Addendum

Re: Contractor Questions and Amendment Comments on 636A6-11-906 Upgrade Stairwells

Des Moines VAMC
Upgrade Stairwells
Addendum

AS-1

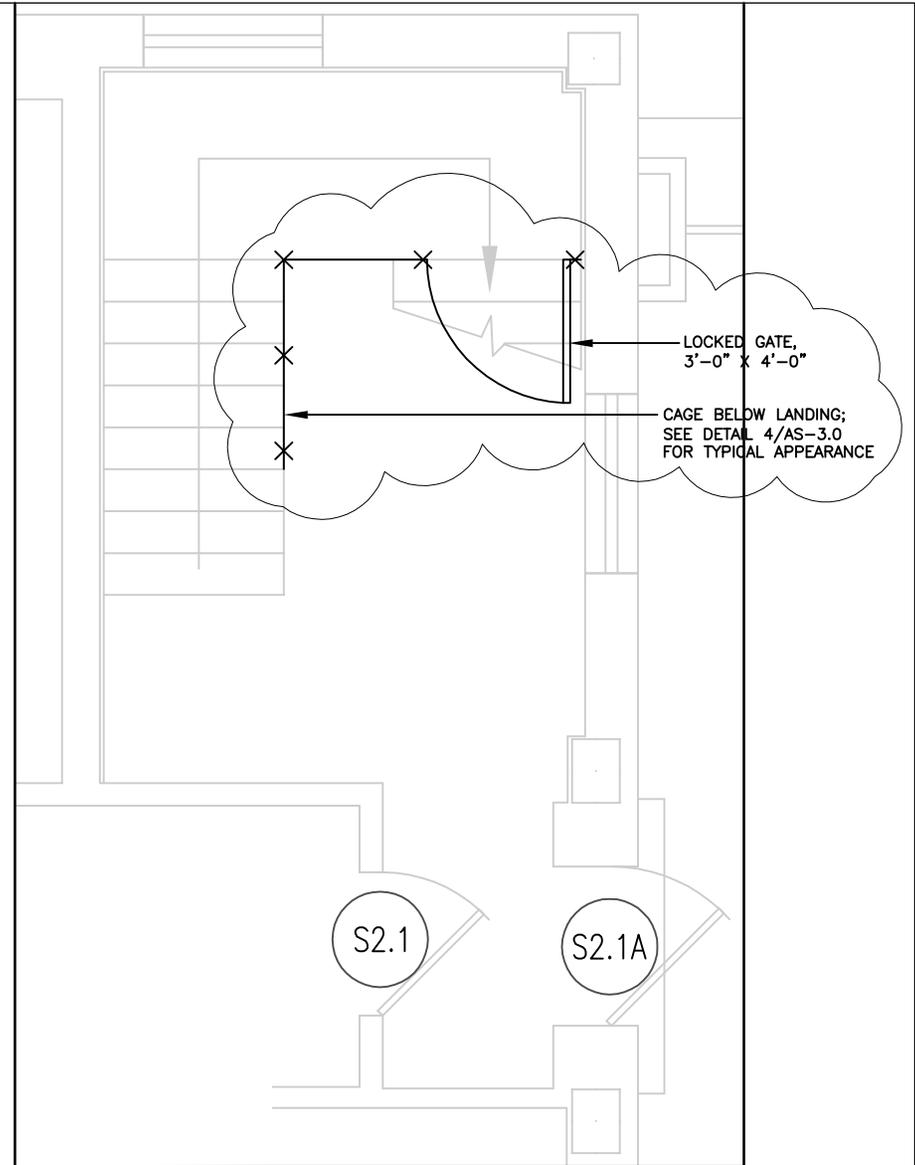
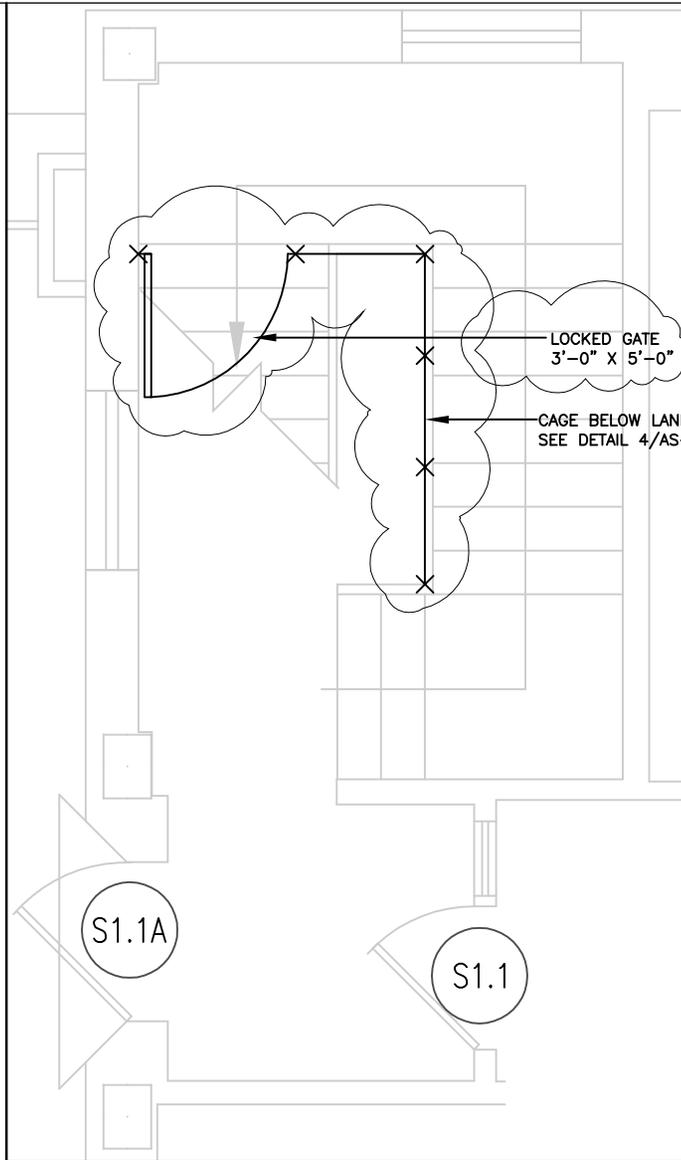
Item 35: Details 1A/AS-2.0 and 2A/AS-2.0 – Delete the requirement for a new cage to be under the stairs at the first floor level of stairwells 1 and 2.

See Sketch AS-1

AS-2

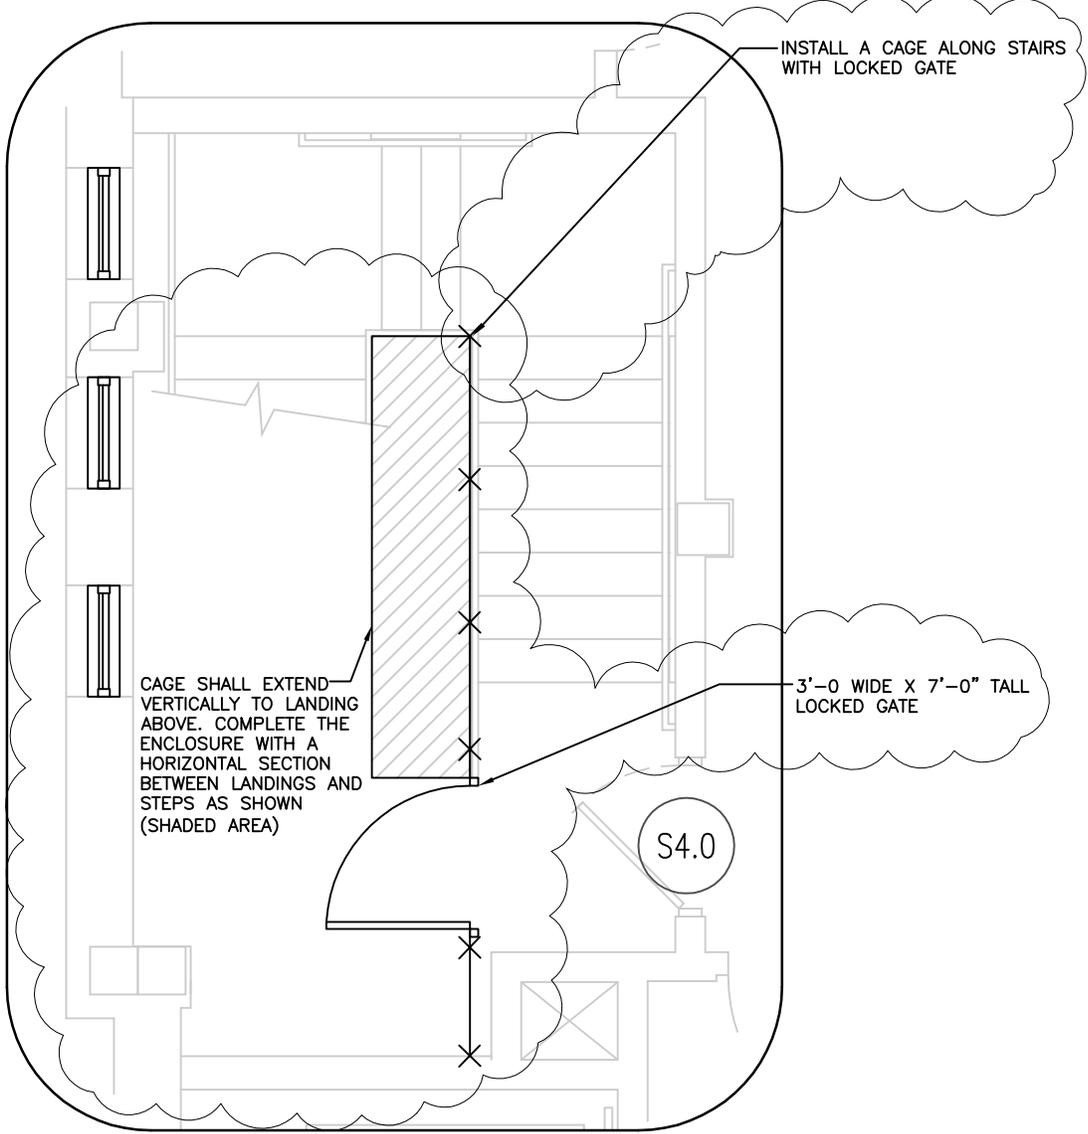
Item 6: In stairwell #4, is there a detail for the rated ceilings to be built?

Item 36: Detail 2A/AS-2.1 – Delete the requirement to construct a rated enclosure in the basement level of stairwell #4. Replace rated enclosure with a chain link cage and lockable gate.

Refer to the attached addendum sketch AS-2 for clarifications.

See Sketch AS-2

AS-3

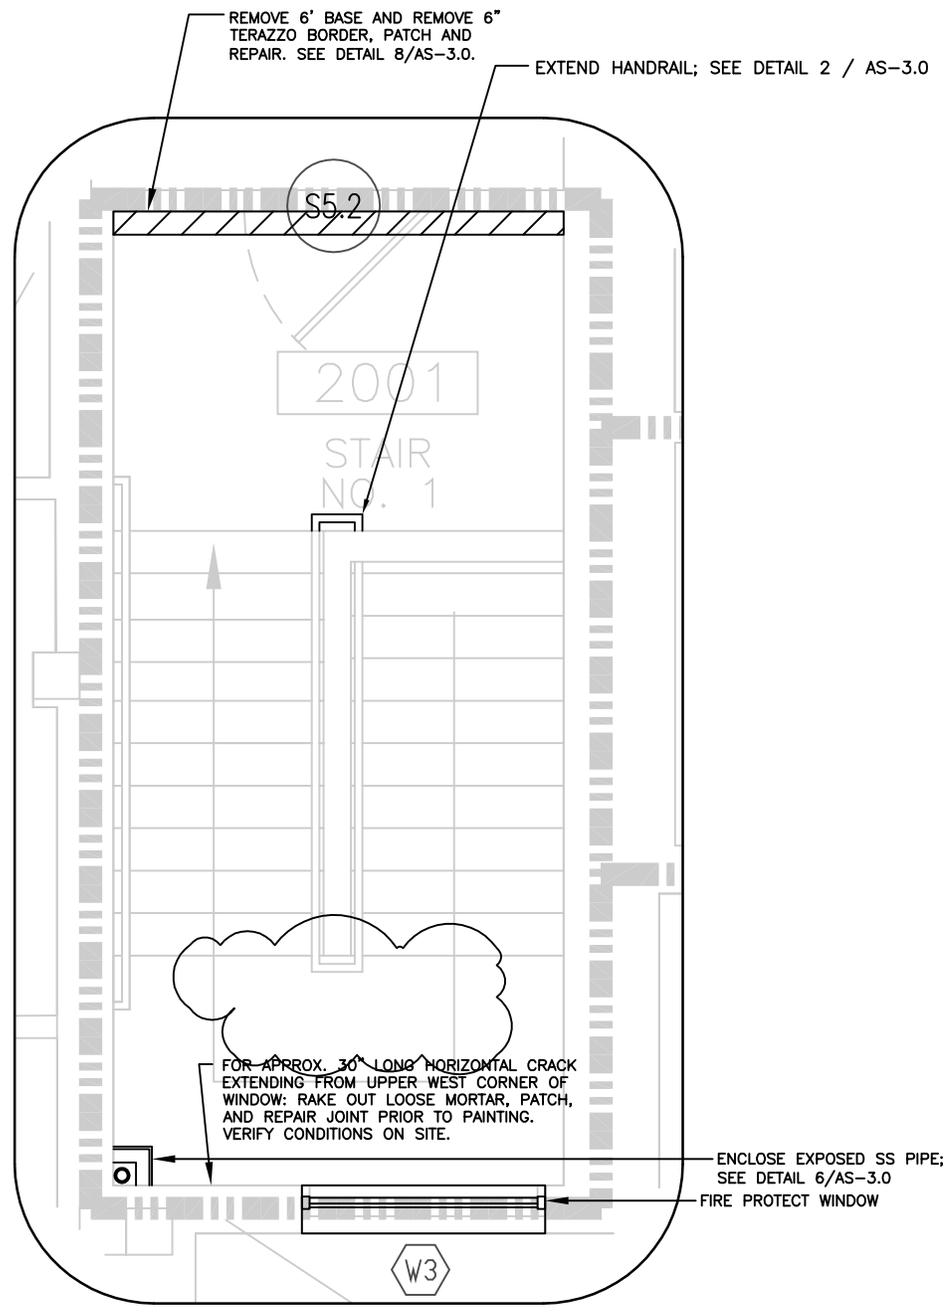
Item 13: Does the 2.5 foot horizontal crack on the wall extending from the upper right corner of the window on the landing between the first floor and the second floor in Stairwell #5 and the crack in the fourth level of Stairwell #6 need to be fixed?

Yes they do. Refer to the attached Sketches AS-3, AS-4, AS-5, AS-6, and AS-7 which modify the construction documents to add crack repair to the contract. Add the following general note to sheets AS-2.0 through AS-2.9: "Repair all cracks in masonry walls within stairwells by raking out loose mortar, patching, and repair joint prior to painting. Verify conditions on site."

SKETCH NO.
AS-5

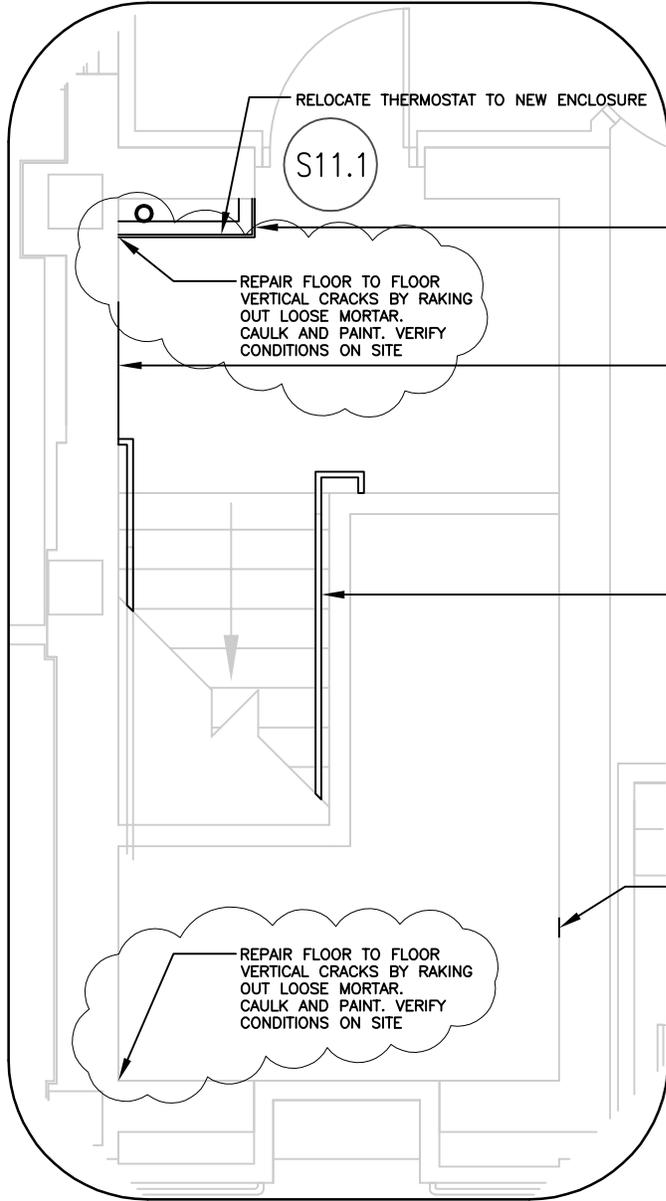
- RELOCATE THERMOSTAT TO NEW ENCLOSURE
- ENCLOSE EXPOSED PIPE; SEE DETAIL 6/AS-3.0
- REPAIR FLOOR TO FLOOR VERTICAL CRACKS BY RAKING OUT LOOSE MORTAR. CAULK AND PAINT. VERIFY CONDITIONS ON SITE
- PATCH AND REPAIR EXISTING, FEATHER OUT TO EXISTING
- REMOVE HANDRAILS AND REPLACE WITH NEW
- REMOVE COVER PLATE, PATCH AND REPAIR
- REPAIR FLOOR TO FLOOR VERTICAL CRACKS BY RAKING OUT LOOSE MORTAR. CAULK AND PAINT. VERIFY CONDITIONS ON SITE

SKETCH NO.
AS-7

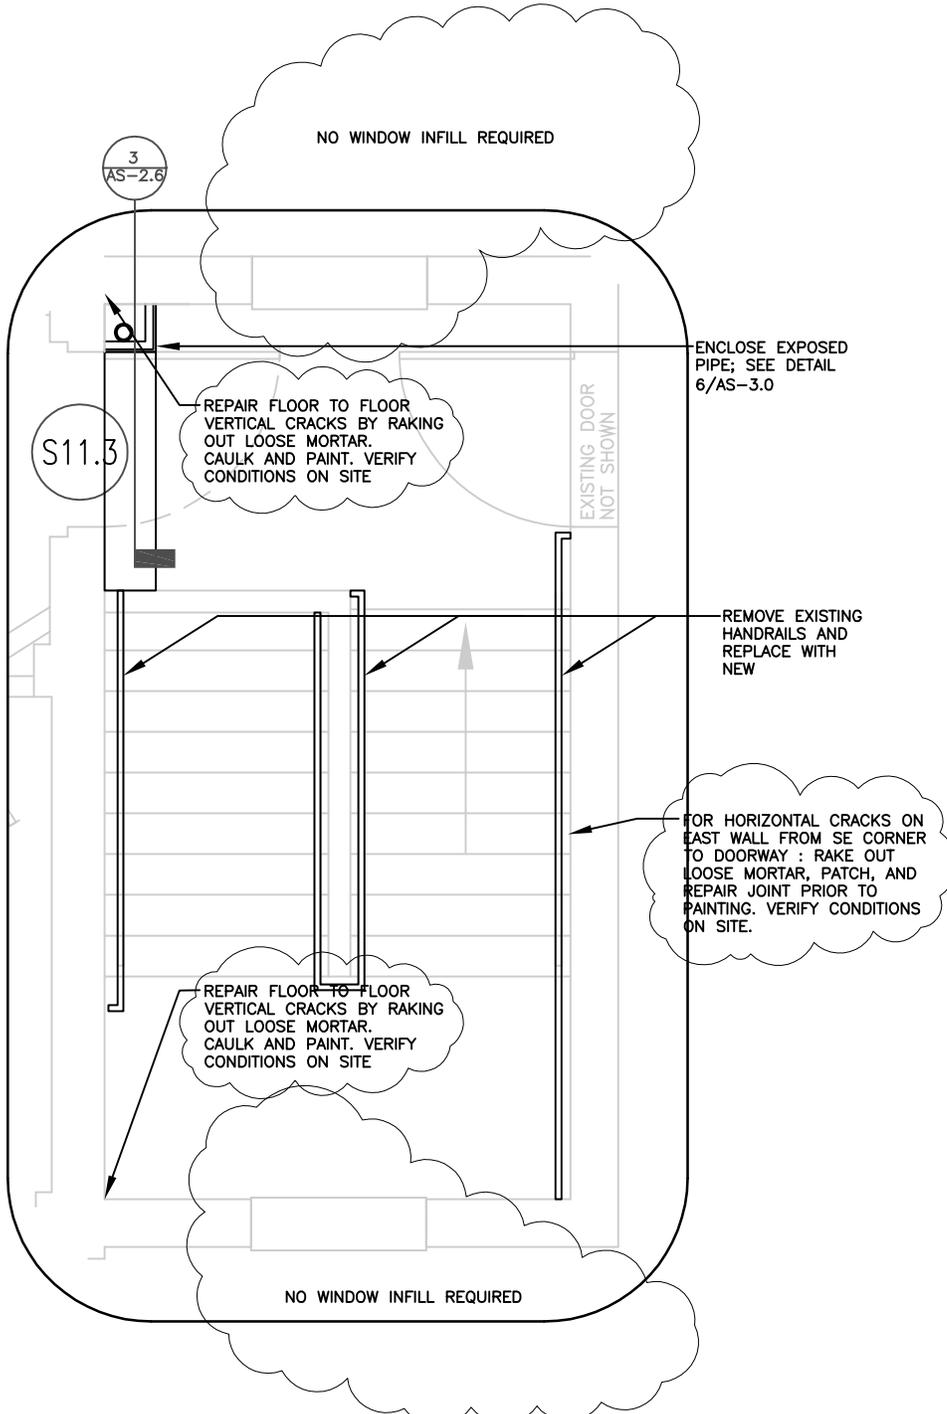
Item 26: Work appears to overlap between this project and the 3B renovation project. Will work be removed from this scope?

Remove window infill work shown in detail 2C/AS-2.6. All other work will remain part of this contract. Refer to attached Sketch AS-7.

SKETCH NO.
AS-8

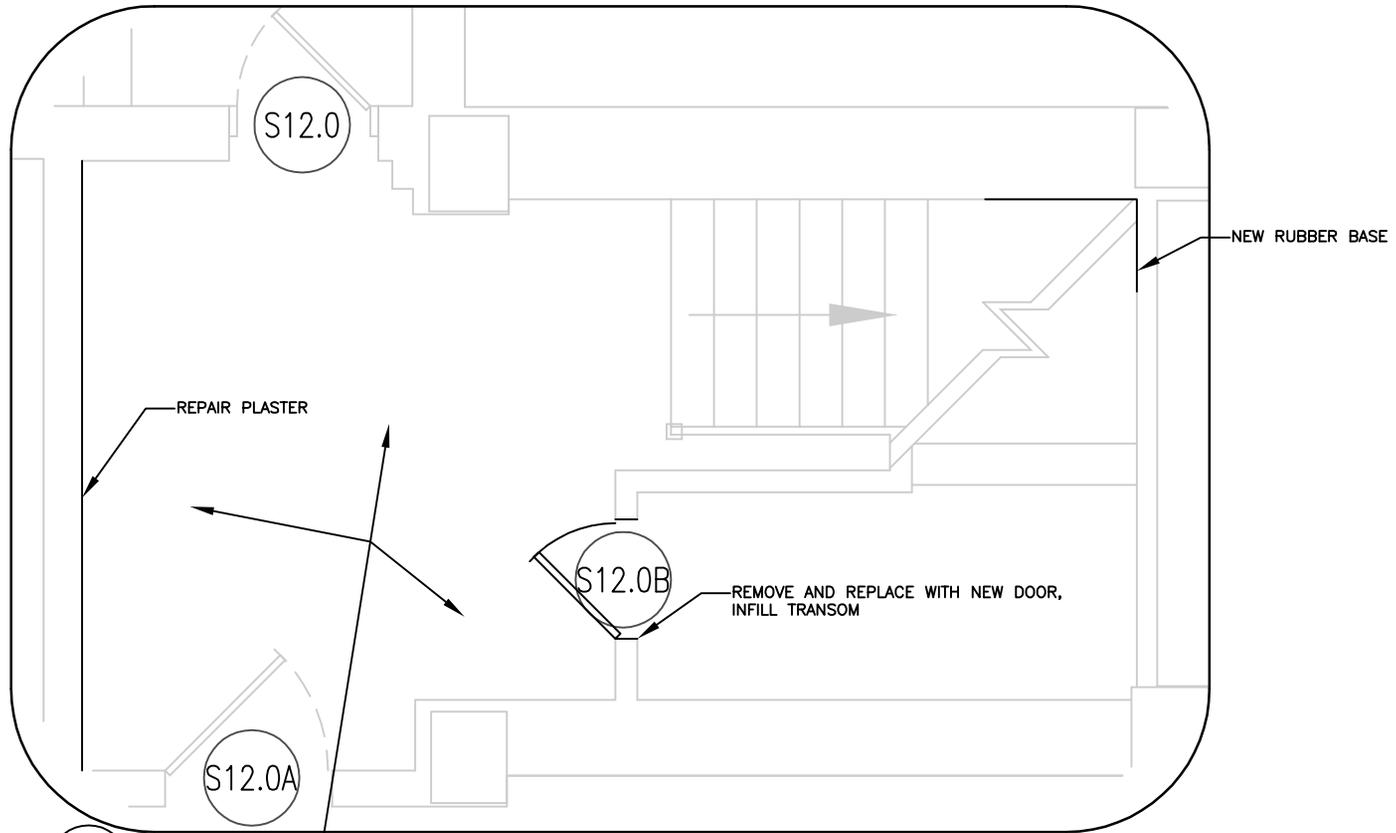
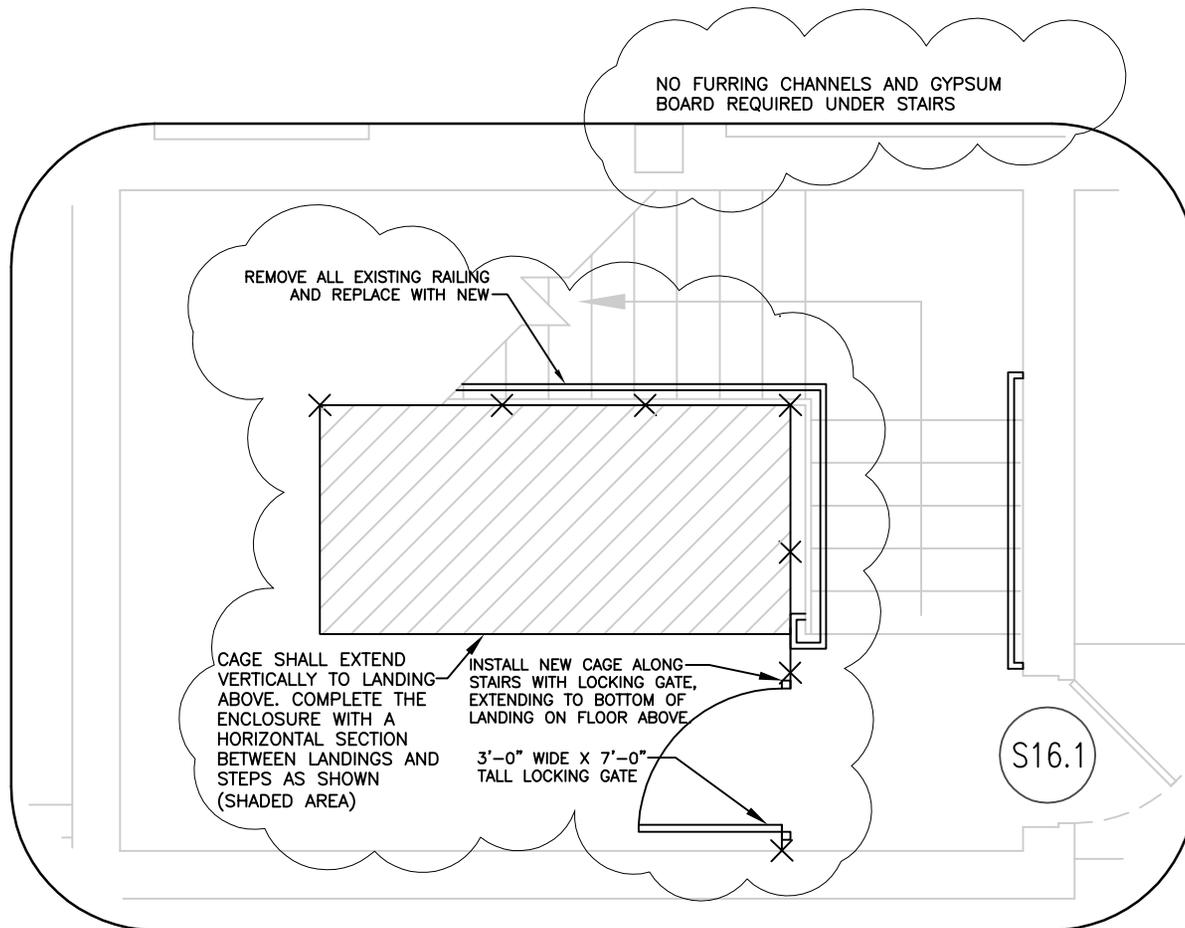
Item 20: Stairwell #12 – Pipes call for fire caulking to be installed. Is the caulking all to be removed and then reapplied?

Yes — refer to Sketch AS-8 for modifications to detail 1A/AS-2.7 which will clarify the contract work.

GENERAL NOTE:
 REMOVE EXISTING EXPOSED FIRE CAULK AND INSTALL NEW FIRE CAULK FOR ALL PIPE PENETRATIONS ON THIS LEVEL. WHERE ESCUTCHEONS ARE PRESENT, REMOVE AND INSTALL NEW FIRE CAULK. NO ESCUTCHEONS ARE TO BE REINSTALLED. ALL NEW FIRE CAULKING IS TO REMAIN EXPOSED AND UNPAINTED.
